Rockwell service bulletin

No. SB-AG-9

RUDDER HINGE INSPECTION

MODELS AFFECTED: MODEL S-2R, SERIAL NO'S 5000 THRU 5082

Figure 2.

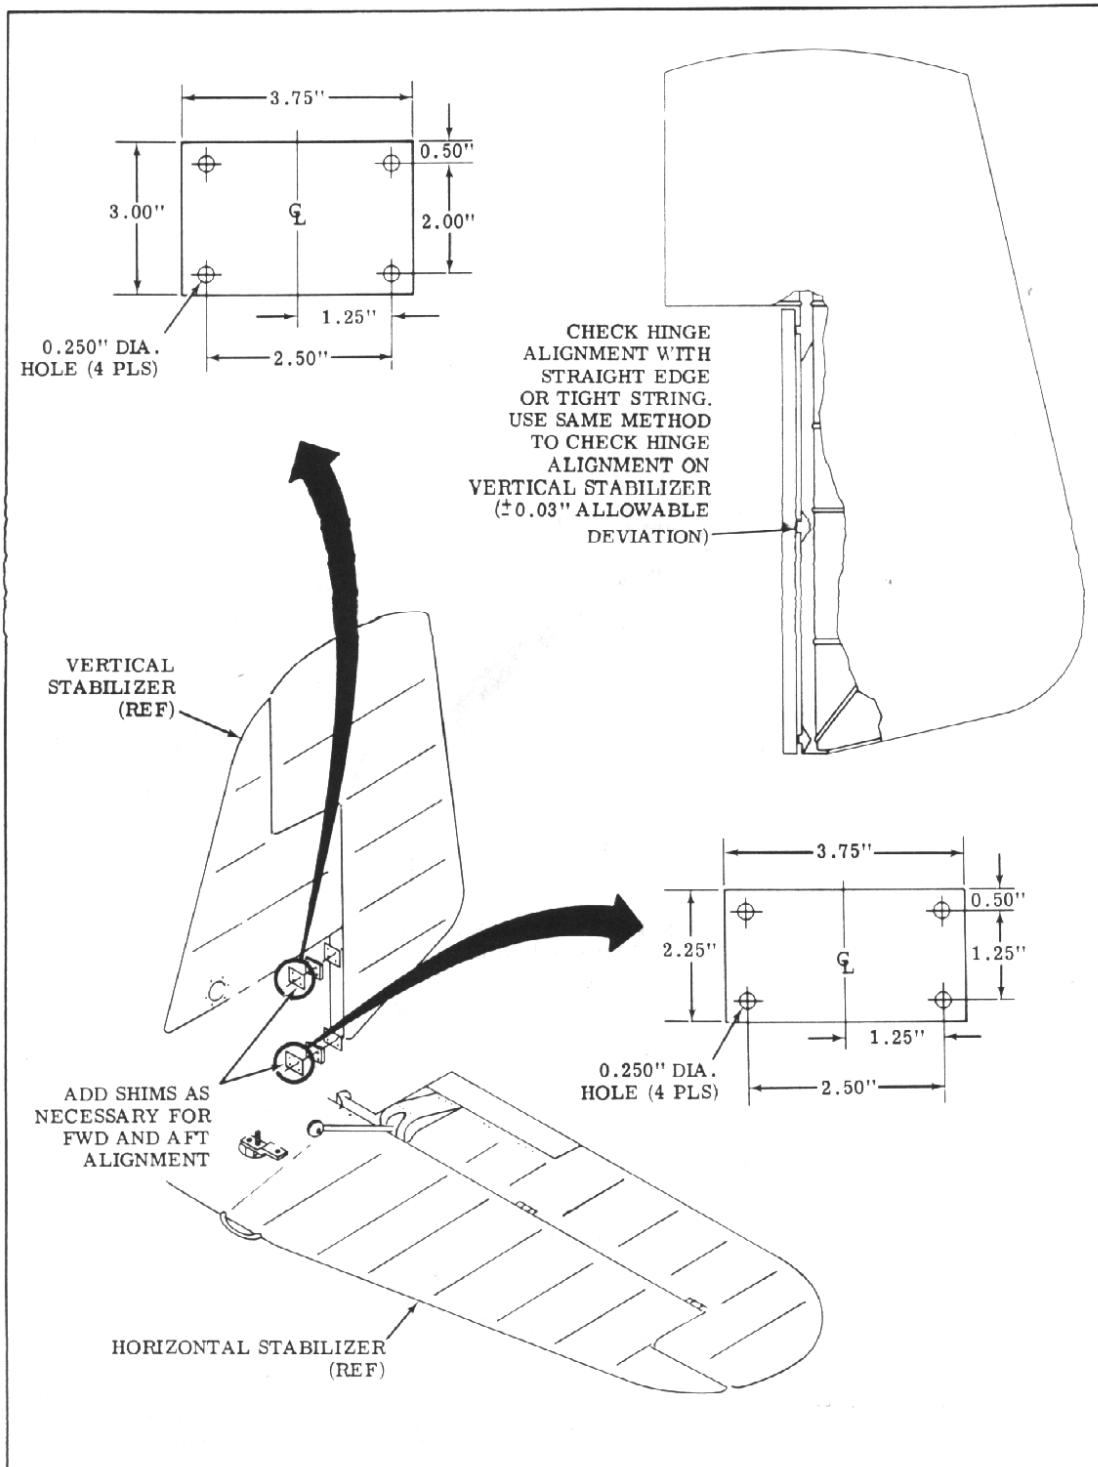
- g. Check rudder hinges with straight edge or a string to assure proper alignment of hinge bushings (see Figure 2.).
 - h. Press fit P26-6 bushing in new bushing(s) (see Figure 1.).
6. Check for left and right alignment of rudder assembly to vertical stabilizer by installing rudder assembly on airplane and installing center and lower hinge pins only. If out of alignment, straighten or replace rudder assembly as necessary.
 7. Repaint and recover rudder assembly in area around rudder hinges with new fabric in accordance with FAA Advisory Circular AC 43.13-1, Chapter 3.
 8. Install rudder assembly on airplane by aligning and installing upper and lower hinge pins first.

9. If center hinge point does not align with vertical stabilizer hinge (forward and aft alignment), add shim(s), as necessary, to vertical stabilizer upper and lower attach point for proper alignment of hinges (see Figures 2.).

Fabricate shims 3.00" x 3.75" (upper shim). 2.25" x 3.75"
(lower shim) from 2024T3 aluminum (thickness as
required) (see Figure 2.).

Figure 1.

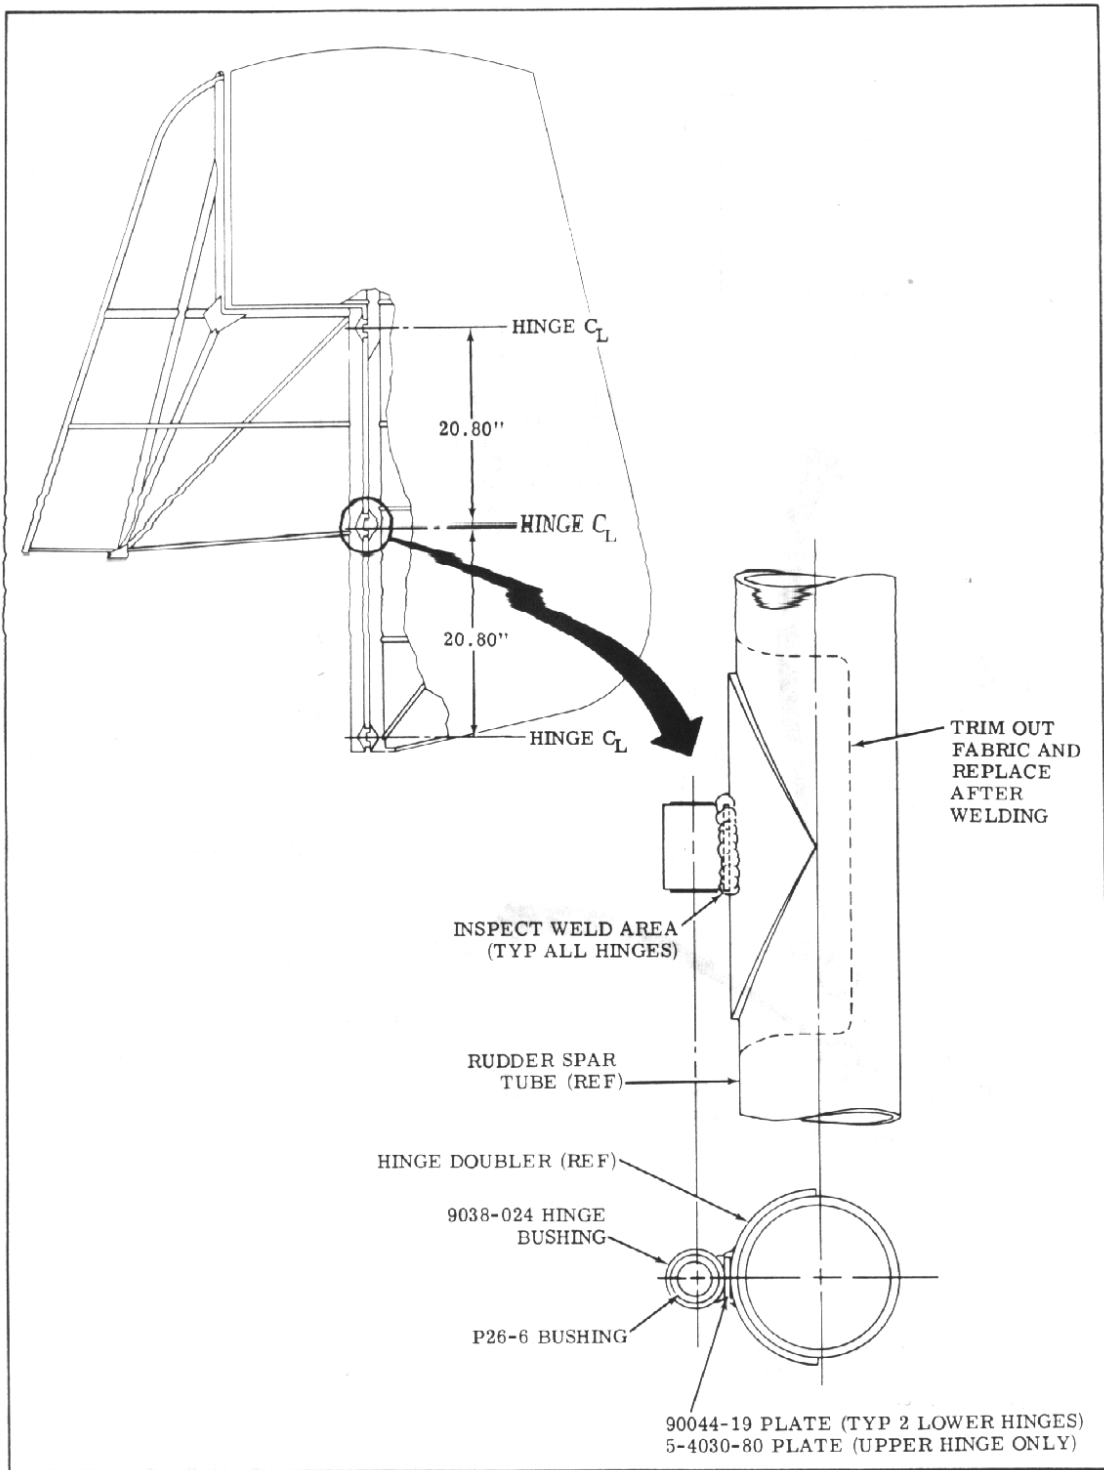
3. Inspect in and around weld bead on rudder hinge bushing for cracks (see Figure 1.).
4. If no cracks are found, proceed to step 6.
5. If cracks are found, proceed as follows:
 - a. Remove hinge bushing and check hinge doubler for cracks.
 - b. If no cracks are found in hinge doubler, proceed to step 5.d.
 - c. If cracks are found in hinge doubler, grind cracked area clean and weld in accordance with FAA Advisory Circular AC 43.13-1, Chapter 2 and grind weld smooth.

- d. Locate and tack weld new 9038-024 bushing and 90044-19 plate (2 lower hinges) or 5-4030-80 plate (upper hinge only) on existing hinge doubler in accordance with FAA Advisory Circular AC 43.13-1 Chapter 2 (see Figure 1.).
- e. Temporarily install rudder assembly on vertical stabilizer to assure no preload on hinges prior to final welding of hinge bushings.
- f. Remove rudder assembly and weld hinge bushings on rudder in accordance with FAA Advisory Circular AC 43.13-1, Chapter 2.

Add a weld bead on top and bottom of rudder hinge bushing plate and grind smooth. Assure that fabric is protected from heat during welding.
